**APPENDIX 4B**

**DETAILED DRAWINGS FOR THE 200 AREA EFFLUENT TREATMENT FACILITY  
CONTAINER STORAGE AREA AND TANK SYSTEMS**

1. ECN 647892

H-2-817970, Sh 1 Rev 1

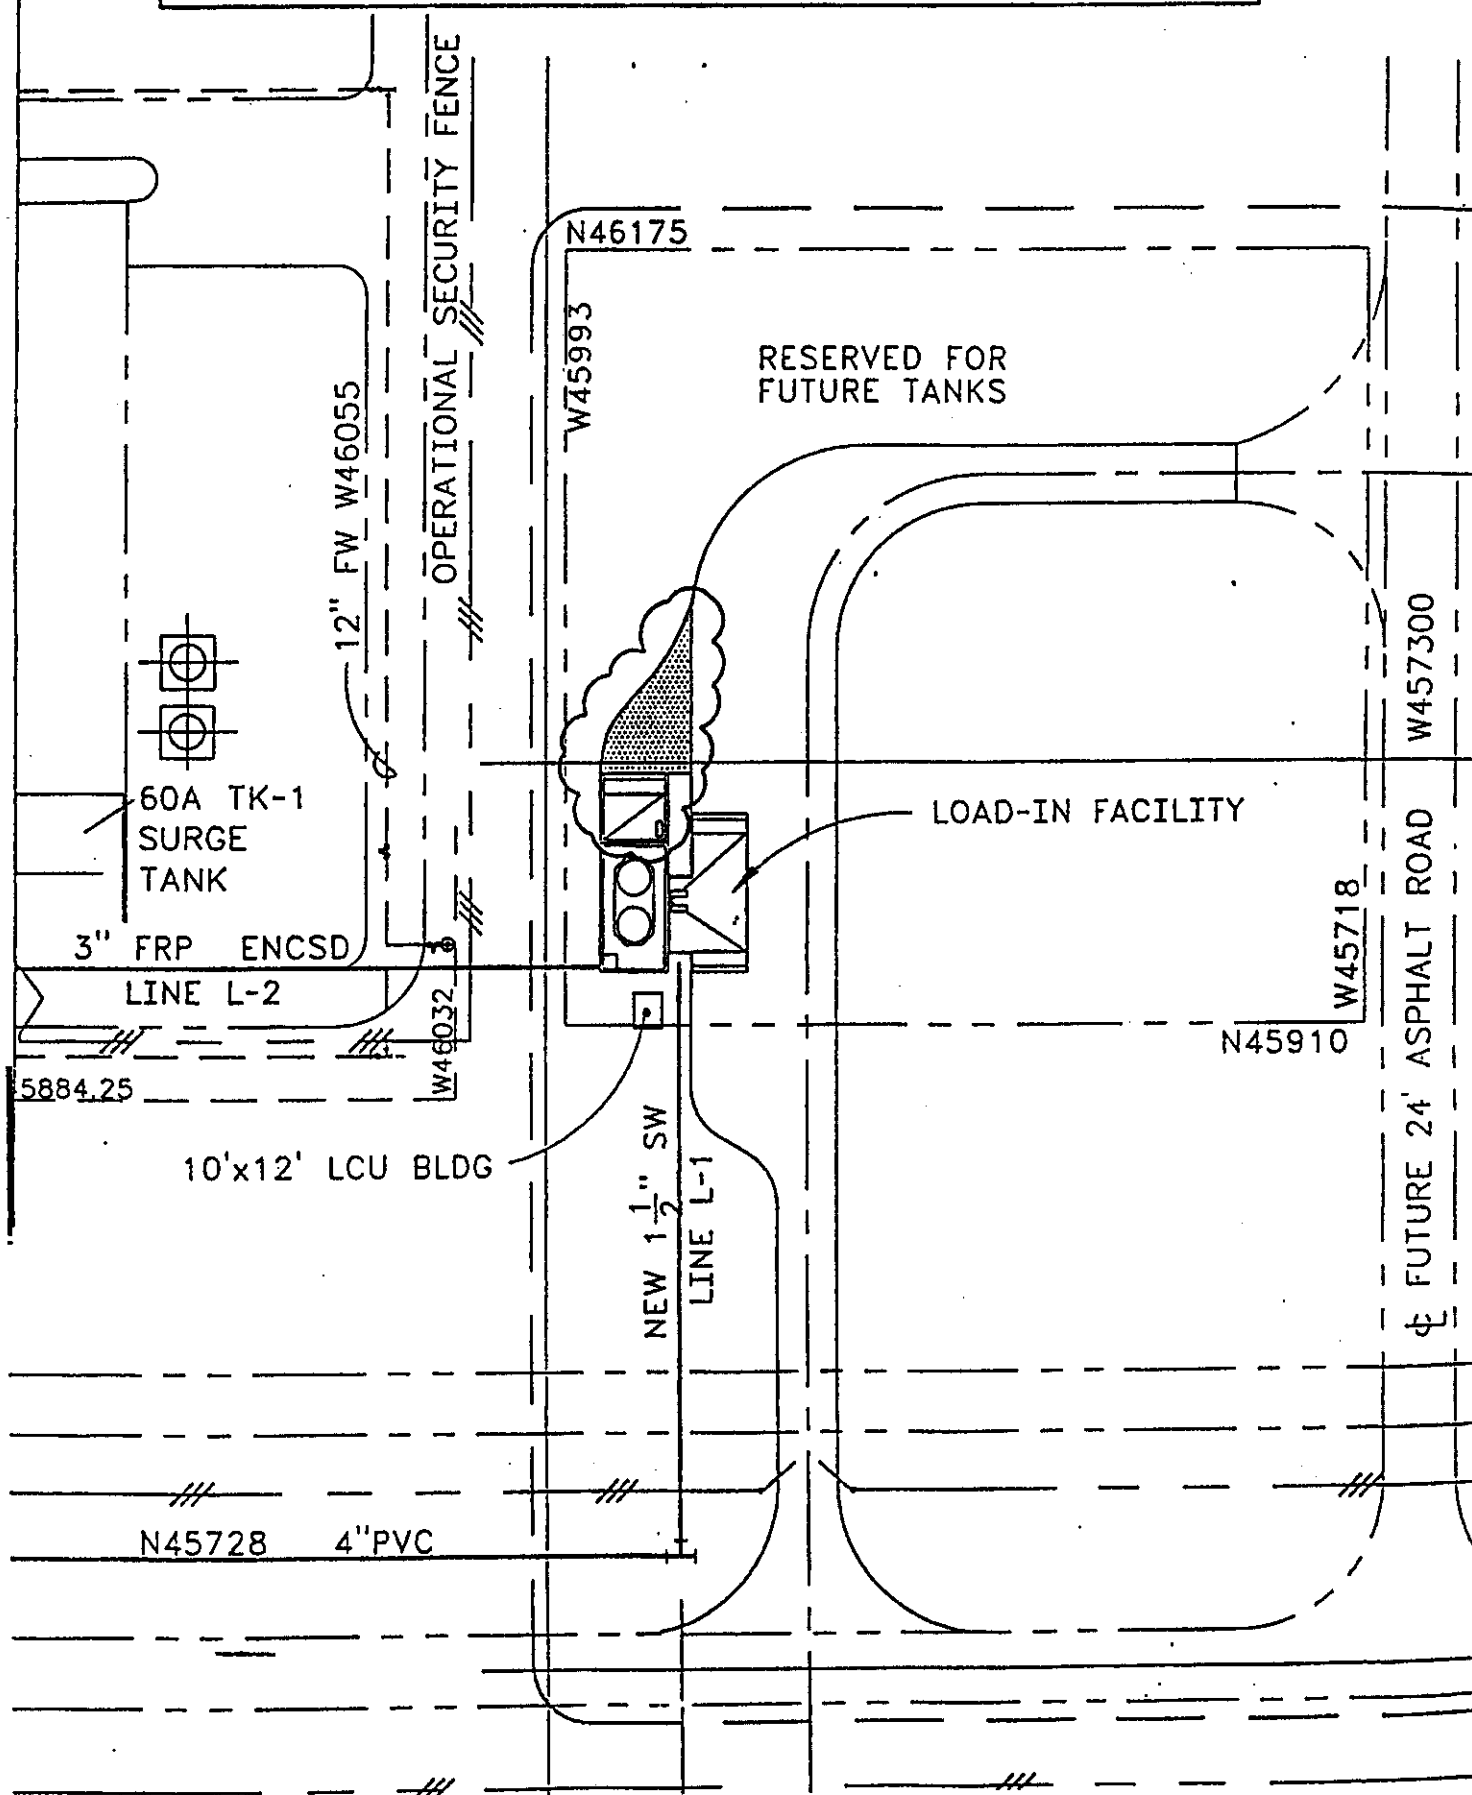
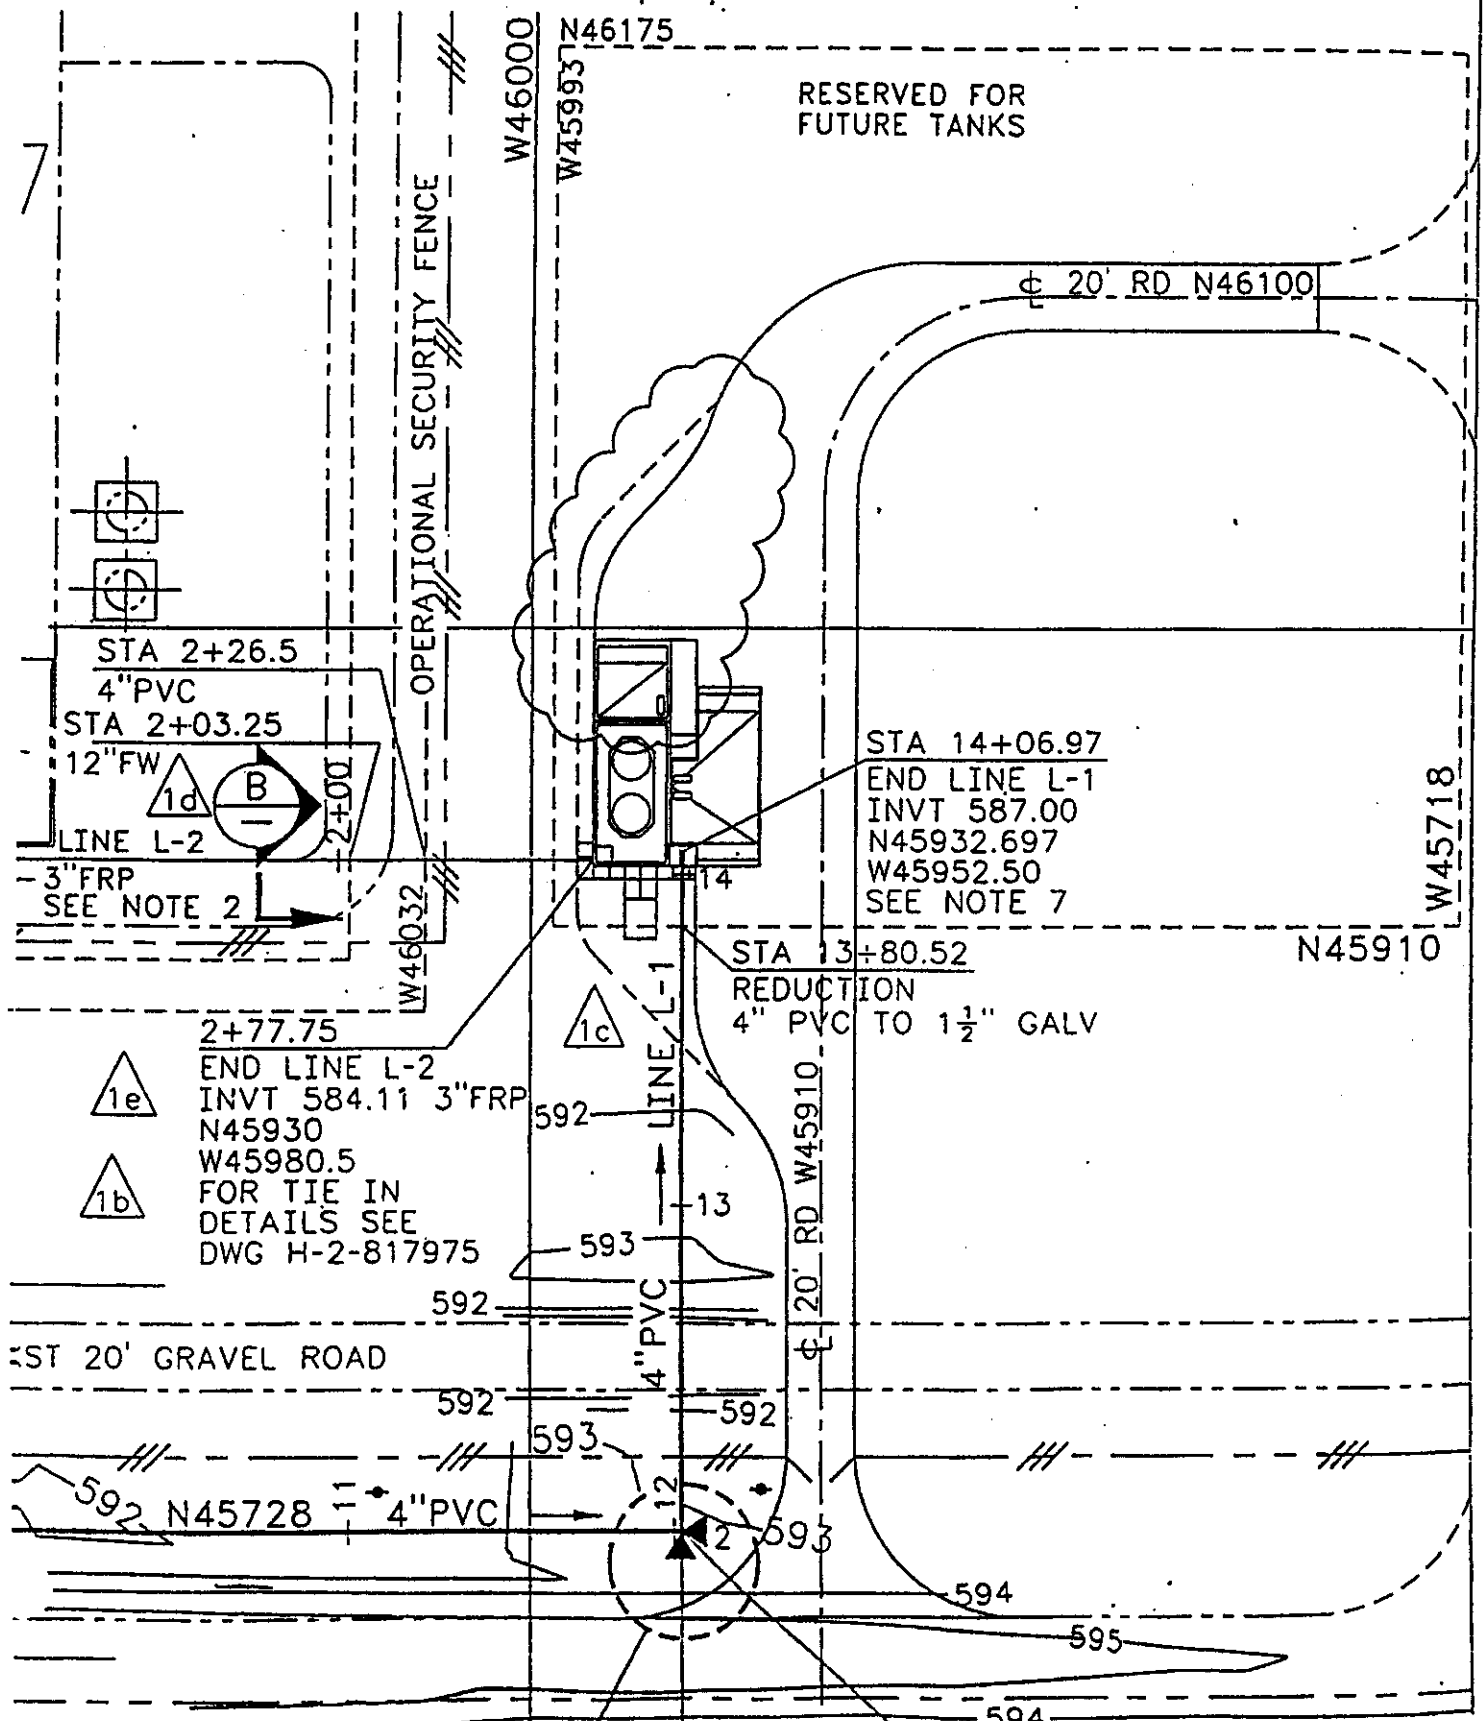
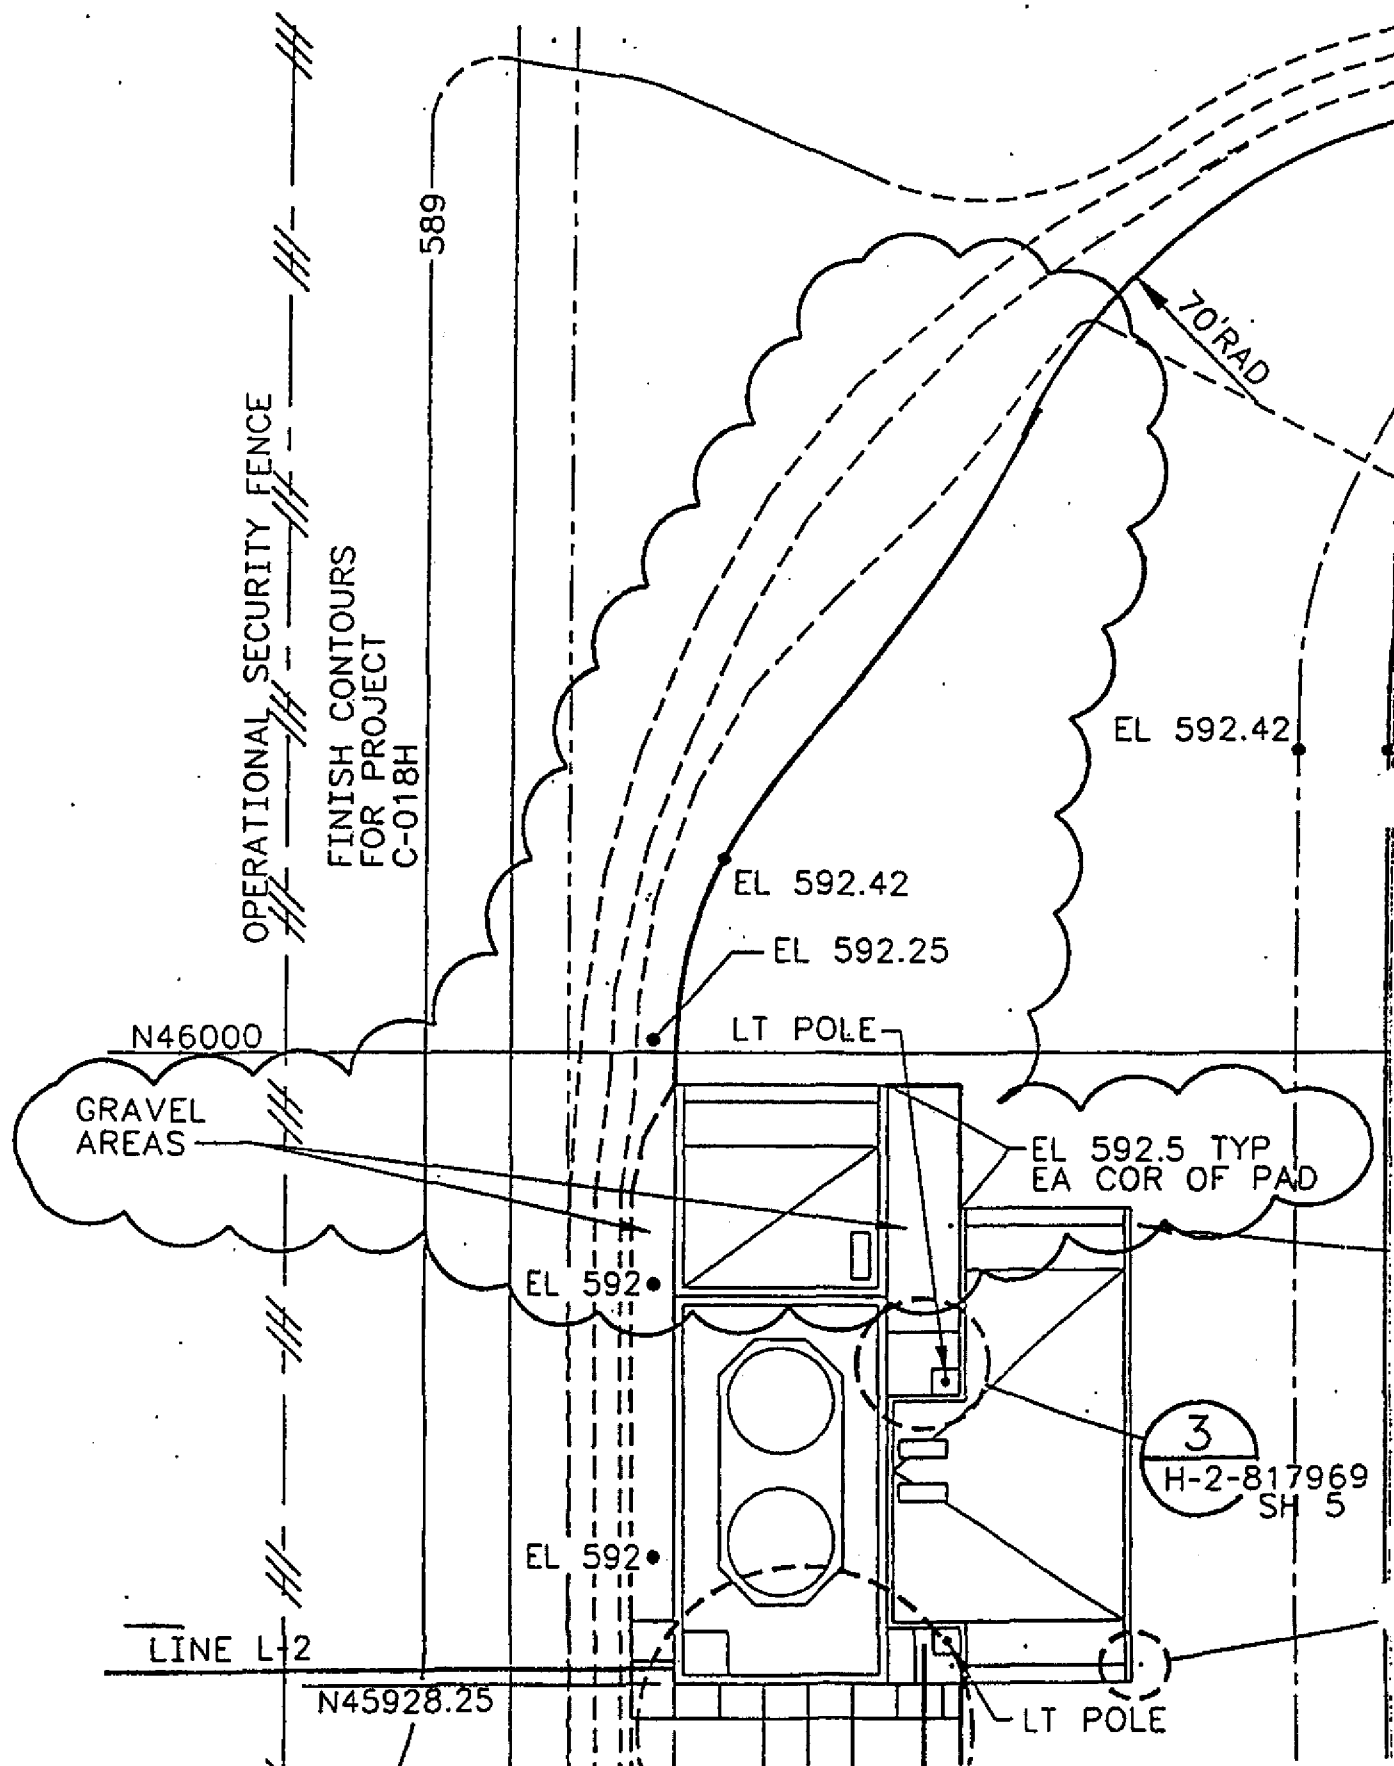
Zones C/F-5/8: Add asphalt and concrete pad areas, filter skid, pump base, dimensional details and Section G reference.

Zones A/D-4/8: Add Sections F and G and Detail 6. Add note to Section E identifying elevations of respective pump pads.

CHANGES/ADDITIONS ARE SHOWN IN CLOUDED AREA, MODIFY DRAWING AS SHOWN IN CLOUDED AREA..
